公众对唐人街分区草案的反馈意见

波士顿市规划局于 2024 年 11 月 19 日发布了唐人街分区修正案草案、分区地图草案和设计指南草案，公众评论期截至 2025 年 2 月 5 日。在整个公众评论期内，规划局工作人员通过民意调查、电子邮件、评论信和请愿书等多种渠道搜集了民众的反馈意见。

图 1 2010 年以来Longwood区的前机构地块

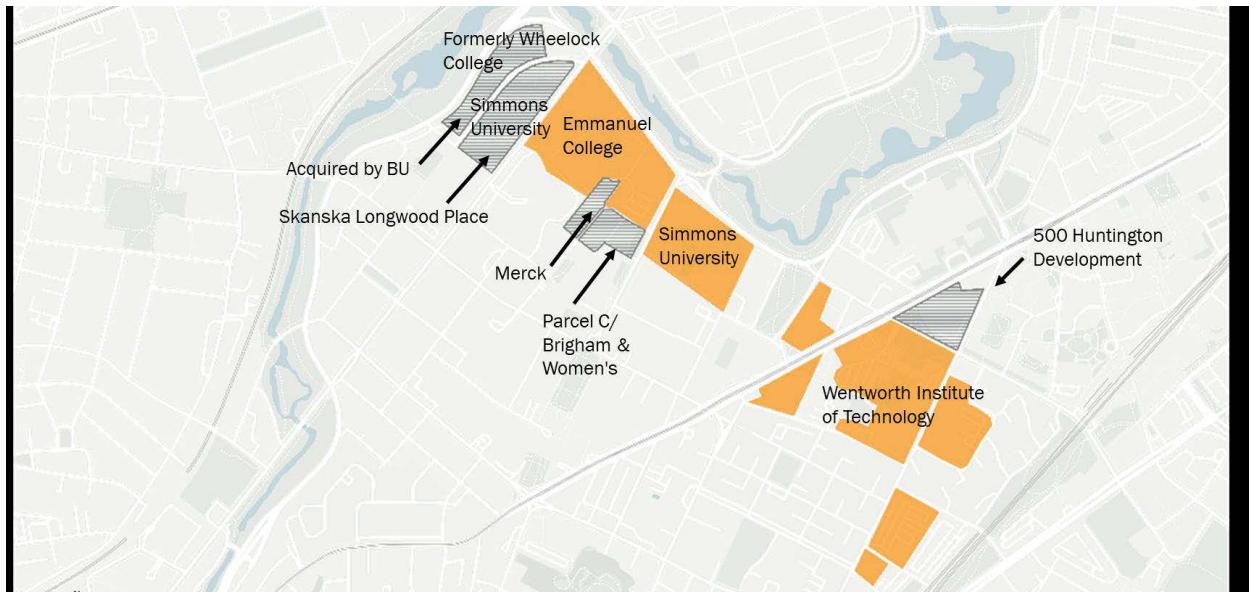
- **Longwood**是一个社区，包含多个毗邻机构。在与城市规划人员讨论的过程中，大家认识到Longwood与唐人街的Tufts大学和Tufts医疗中心以及其他类似位于社区内的机构有很大不同。Longwood本身就是一个社区。除了一侧的 Mission Hill 外(机构物业被绘制在 IMP 内)，Longwood 也没有被其他社区所包围。它与邻近社区之间由主干道和 Emerald Necklace 路段组合而成。因此，对机构园区边缘物业的担忧并不适用。
- **Longwood**的 "排除"通过IMP进行管理，并增加了兼容用途。Longwood从综合管理计划中撤出的土地用途通常从教育用途转为支持Longwood研究、生命科学和临床需求的用途。地图如下。随着Simmons住宅园区的重建，办公、生命科学和住宅用途的发展预计将以同样的方式继续下去。

这突出了研究实验室作为Longwood区任何重新分区允许用途的重要性。
